CHARTER TOWNSHIP
OF YPSILANTI
PLANNING COMMISSION

REGULAR MEETING AGENDA

**Preliminary Site Plan and Special Use Review
For
Ypsilanti Charter Township, Michigan**

RE: Sunco Quick Oil Lube Center
Site Plan Review #4

PROPOSED FRONT ELEVATION

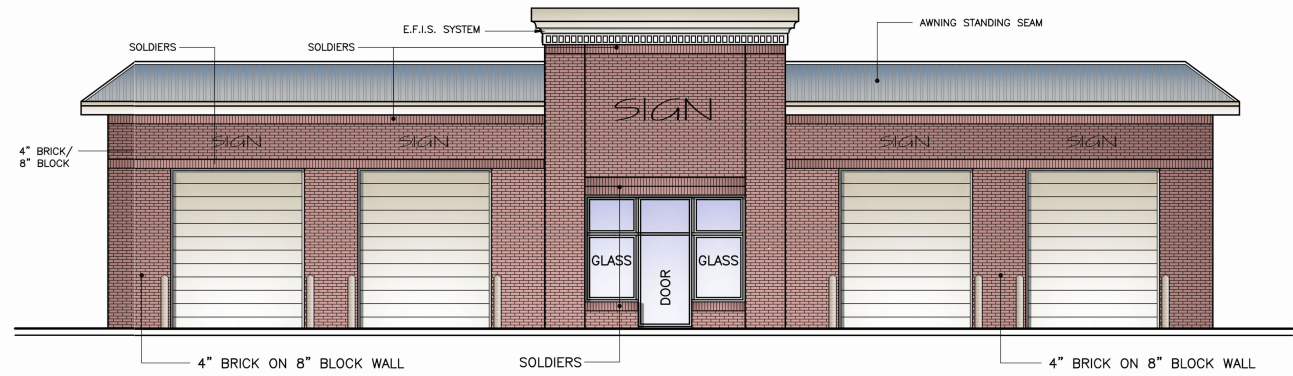
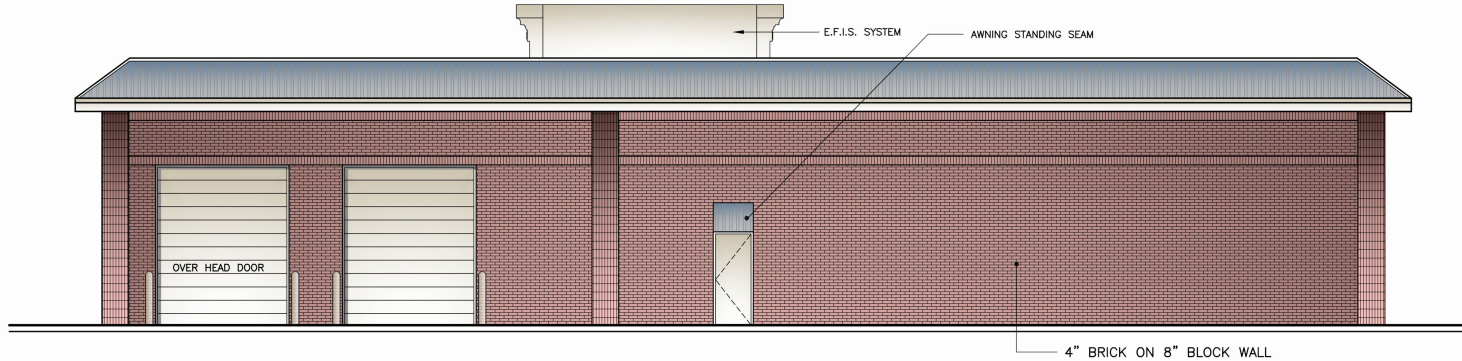
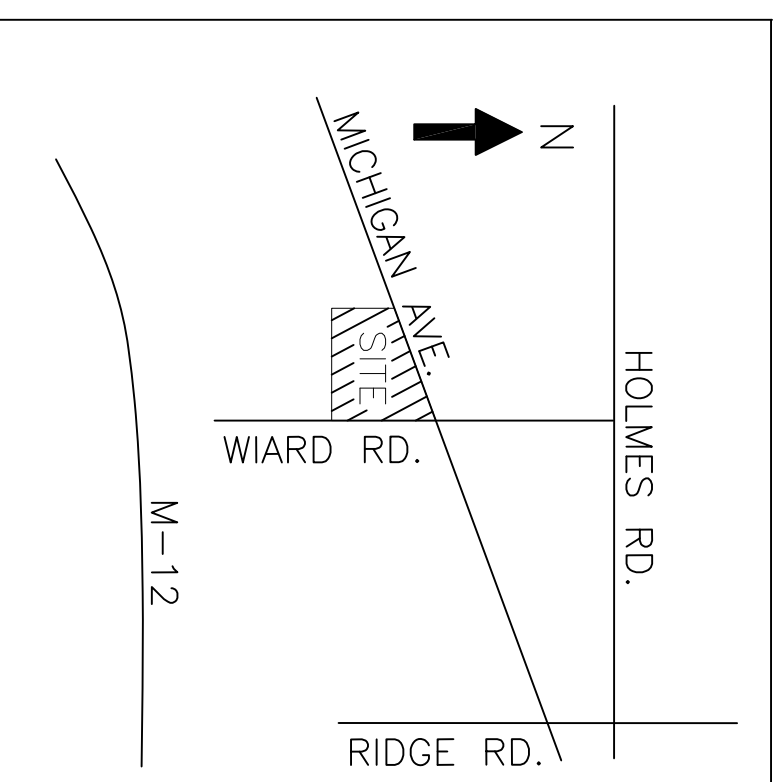
The applicant should provide full color elevations to fully understand the architectural treatment of the building.

7. The applicant shall revise the proposed architectural design to be consistent with the proposed building dimensions and interior layout, as it currently appears the architectural design is referring to a previously proposed 3,568 sqft building.

Items to be Addressed: *Provide full color elevations.*

VEHICLE TURNING TEMPLATE NOTES:

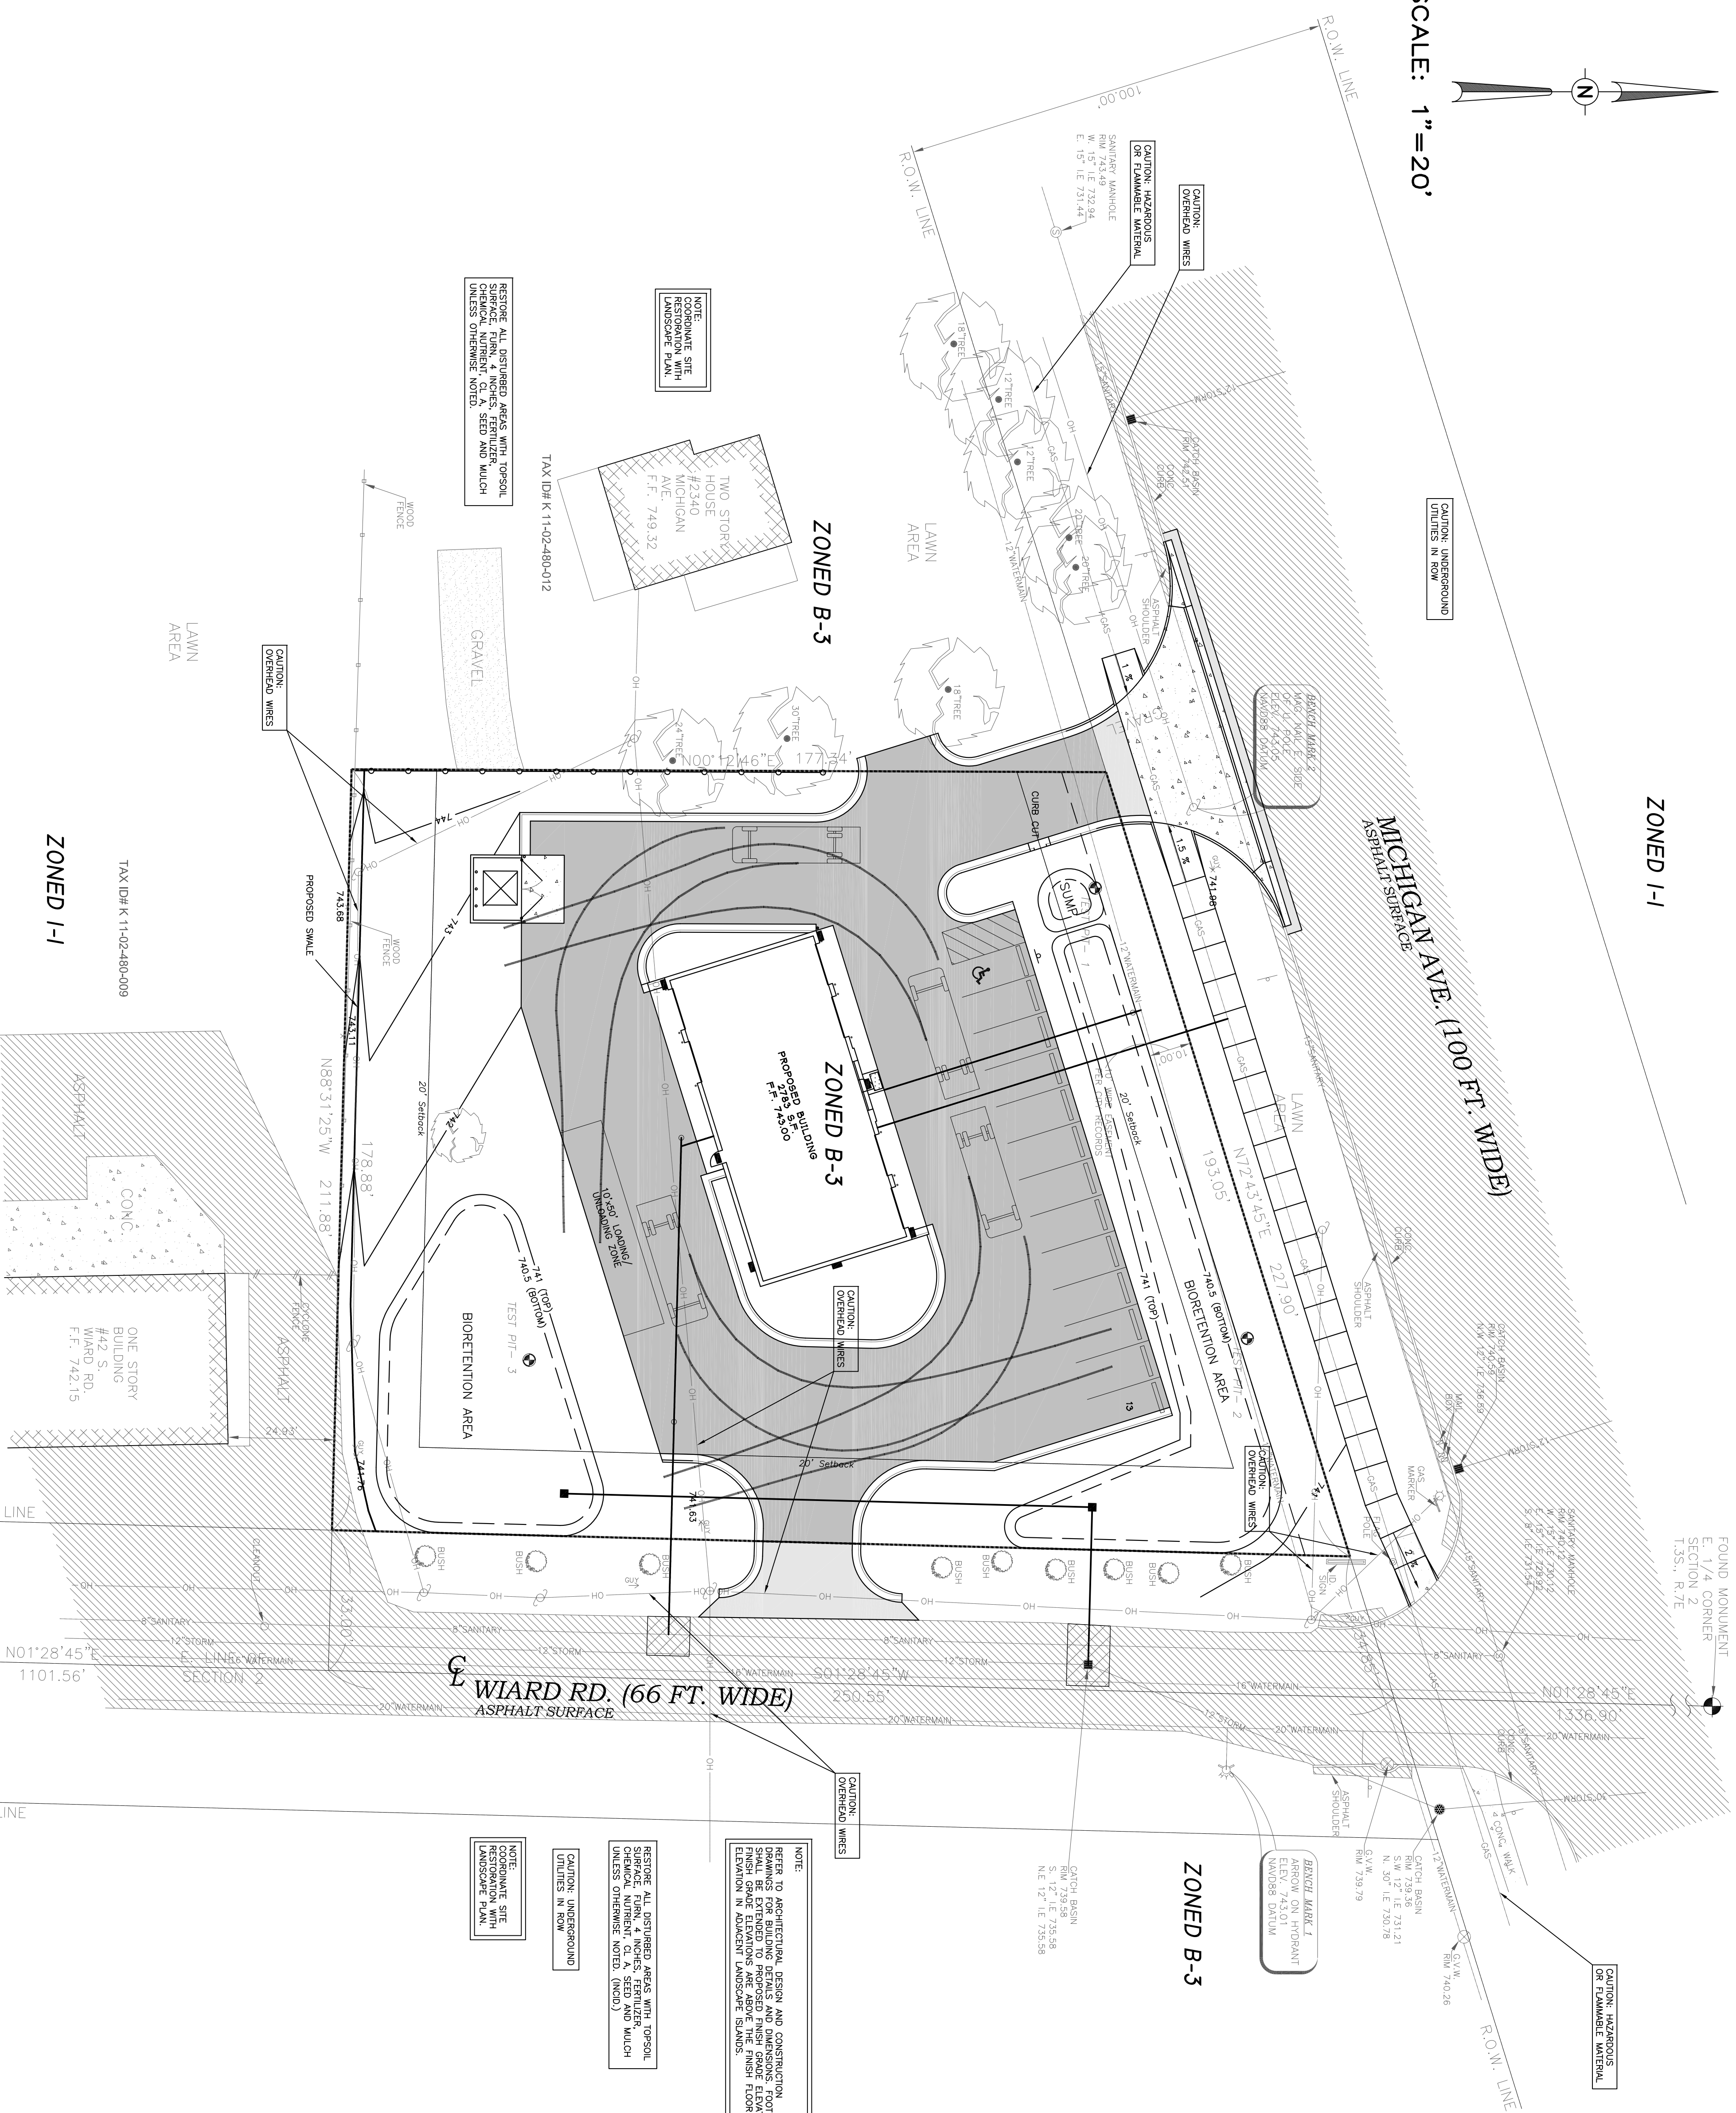
1. The applicant shall revise the provided Truck Turning Template to account for a Fire Truck with an overall length of 35-feet, instead of the current parameter of 30-feet. It is recommended that the template show the turning motion from Michigan Avenue onto the site and through the north side of the parking lot.
